Subject	2-32 SMITH STREET SUMMER HILL CONCEPT PLAN APPLICATION
File Ref	FLOUR MILLS
Prepared by	Con Colot - Senior Strategic Planner & Projects
Reasons	Respond to public exhibition of Concept Plan Application
Objective	Council to advise Department of Planning & Infrastructure on Council issues regarding Concept Plan Application

A Concept Plan application for *a mixed use residential, retail and commercial development* on the former Allied Mills site in Summer Hill has been lodged with the Department of Infrastructure and Planning (DOPI), and is on public exhibition between 29 June 2011 and 12 August 2011. DOPI will assess the application and provide a report to the Planning Assessment Commission who will determine the proposal.

The purpose of this report is to describe the application, make recommendations on what to advise the DOPI, and for Council to determine its response to the DOPI.

Extract of Concept Plan showing perspective and how buildings and landscape are arranged around the site.

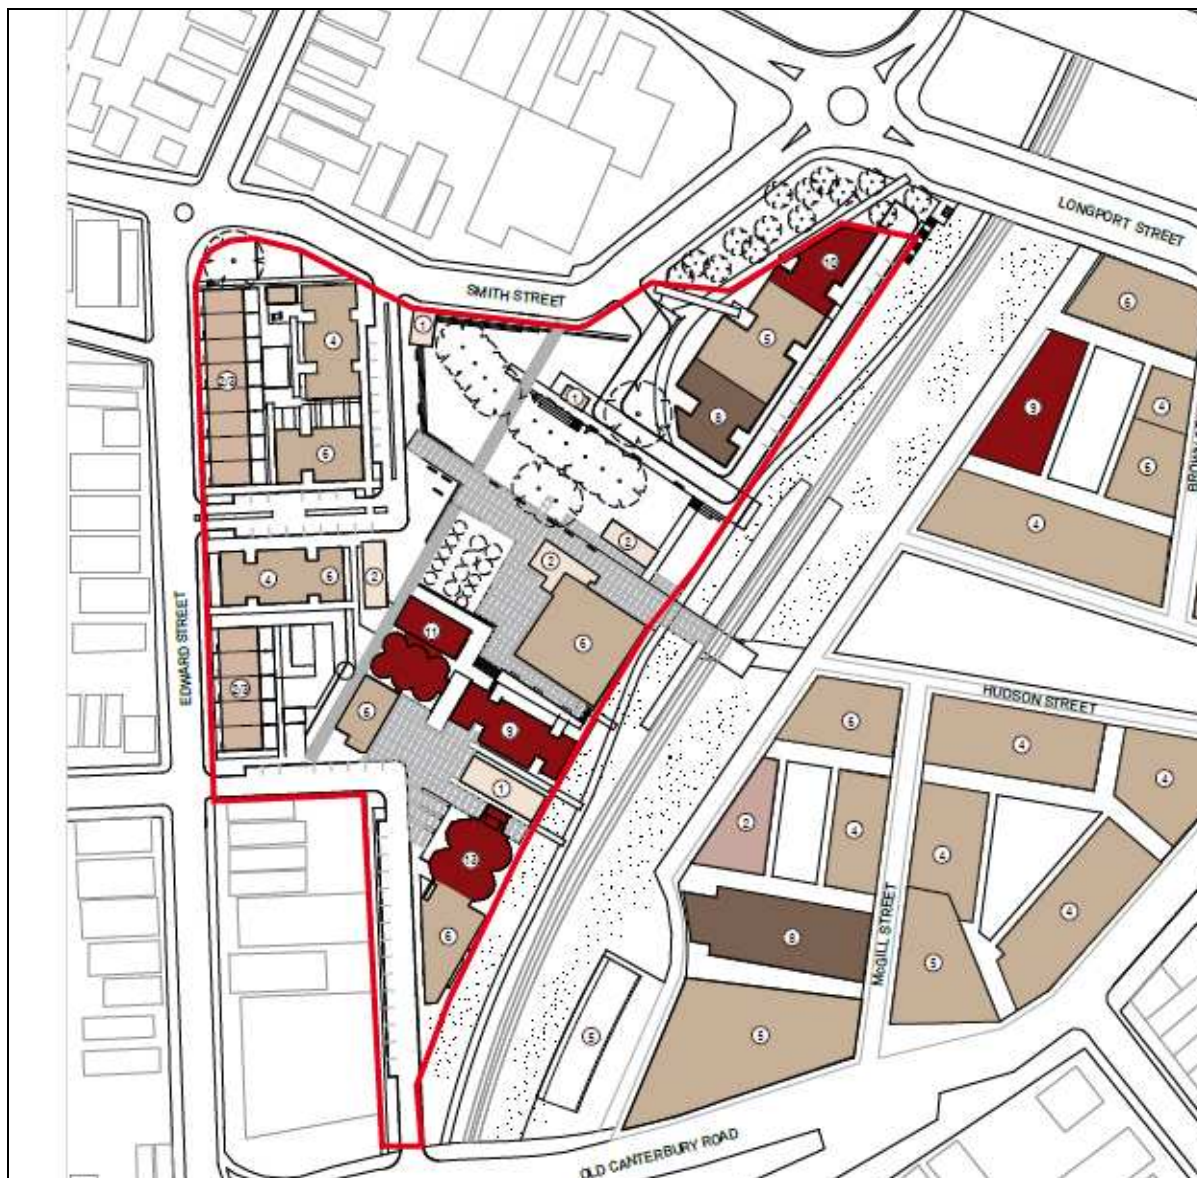
The applicant's perspective drawing in this report shows the degree and quality of the design of the site.

An alternative lower impact urban design option along Edward Street would be to have a continuous line of low rise buildings (architecturally modelled, detailed, and landscaped to respond to the typology of the heritage housing along Edward Street), with a minimal gap between buildings for a footway, framed by tree planting, leading to the middle of the site. Any other buildings behind this should have been limited to four storeys, not six storeys. Roadway access could be off the

One key viewpoint vista is down Smith Street, looking east toward the former Flour Mills site. Whilst the middle 5 storey part aligns with the axis of the vista down Smith Street, presumably to respect this vista and give a distant 'mid level' rise visual impact. However, it is likely the taller 8 and 10 storey parts will be able to still be viewed, resulting in a profound change in character and scale for the area.

Site Plan showing potential area for public open space.

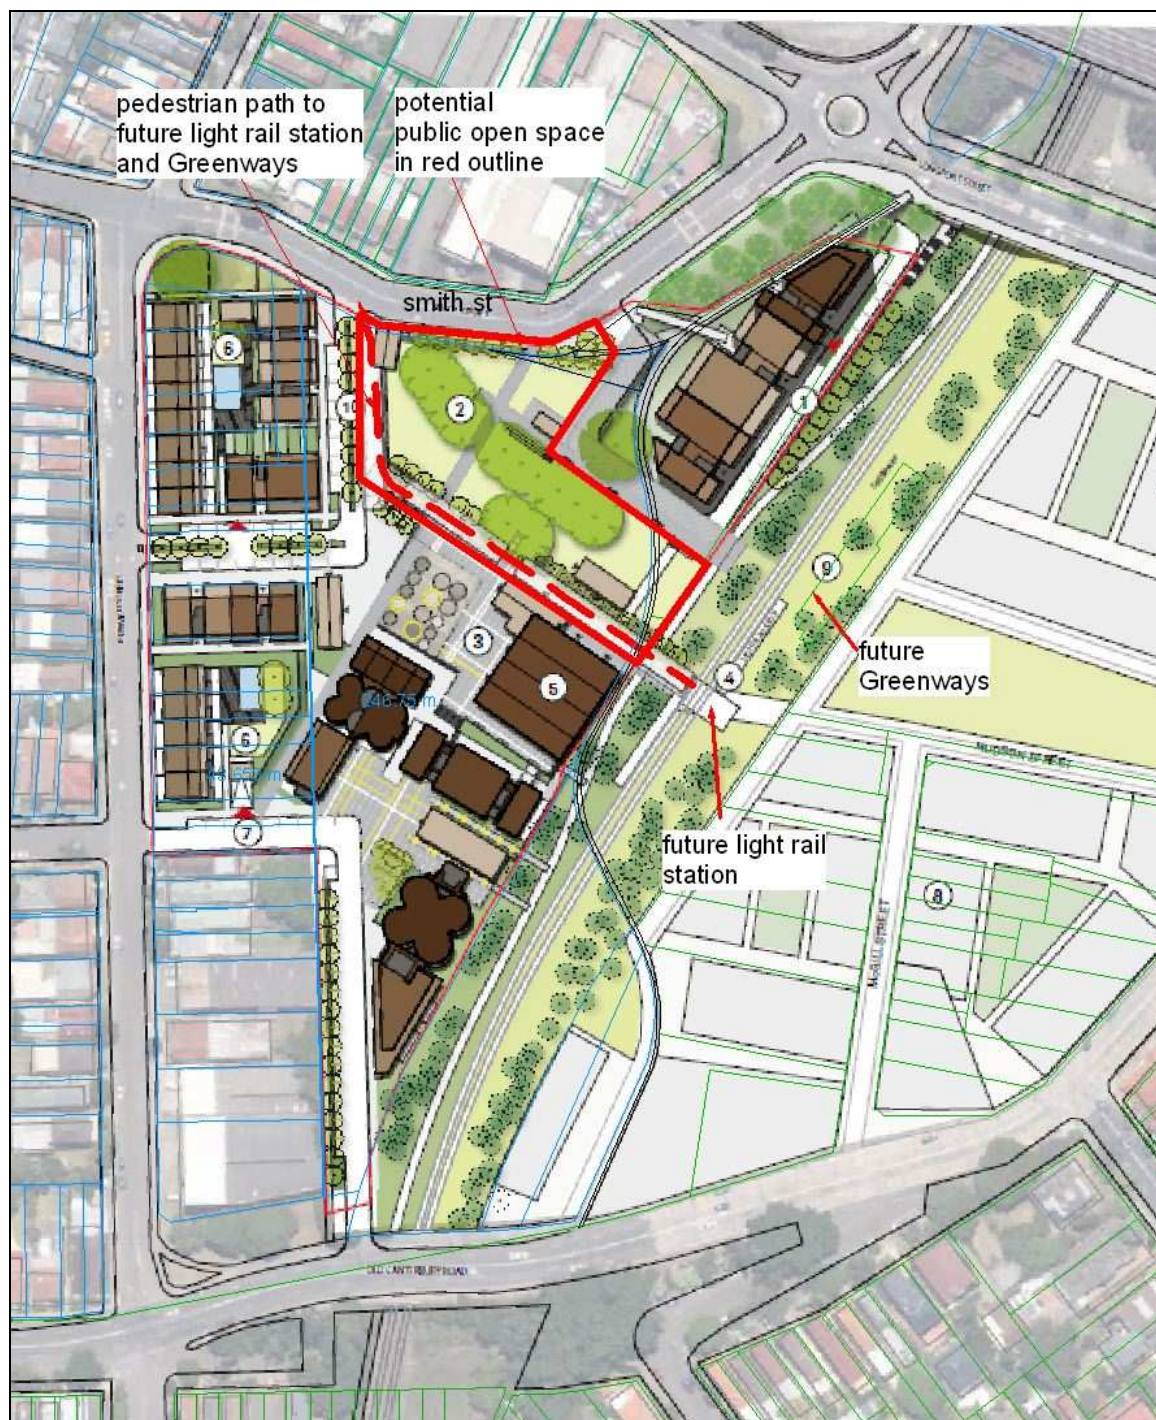
The proposal's design provides a type of small 'private park', of approx 4,500 sqm (equivalent of approx 9 modestly sized house blocks), to the north west of the Mungo Scott building, between Smith Street and the Hawthorne Canal. This is shown on the site plan on the next page. This area has a unique and rare opportunity for future public open space. This is a relevant matter for consideration at Concept Plan application stage, since the DGRs (Public Domain - Open Space) requires resolution of the matter for linkages to the future light rail station and GreenWay, and connectivity to the proposed park to the east of the site within Marrickville (shown in the McGill Street Masterplan). Also, if Council had been in a position to determine new 'uplifted' land use controls for the site in the Ashfield LEP, it is possible that this matter would have been pursued as a normal part of town planning considerations.

These statements leave the matter to be sorted out in ‘future stages’ of the development. Such an arrangement is unacceptable and would make the issue of public access very difficult to resolve – one can envisage a future scenario where we see a strata corporation unhappy with “their open space” being used by the general public whilst strata corporation fees are being collected to assist in its maintenance and up keep.

In addition, the proposal includes the provision of buildings within this open space which could be used for commercial/retail purposes. The specific use of these buildings has not been defined or detailed in the proposal. Should Council wish to pursue the dedication of the major communal open space as public open space then these buildings should be removed from the concept plan.

The matter of dedication of public open space should therefore be addressed prior to any Concept Plan approval. This should be undertaken by specifying on the plan the location and area of land to be dedicated, and showing on the Staging Plan when it is to be dedicated. This should preferably be developed as part of the first stage of the development so that all subsequent stages of the proposal have access to this space. The dedication of identified public open space should also form part of the Statement of Commitments.

It would benefit the local community if the land was made public open space, after its development, and vested into Council ownership. The DOPI should also be requested to assist with this given the access the public open space would provide to the State government funded and managed future light rail station.

2/3 Requirements for dedication of public open space to Council referred to resolution B1 be placed in the Set of Commitments on any Concept Plan approval.

3/3 Dedication of the public open space referred to in Resolution B1 occur after the public open space has been created including all landscaping and open space fit out, and no later than the completion date for any Stage 1 development, and this be reflected on the Staging Plan.
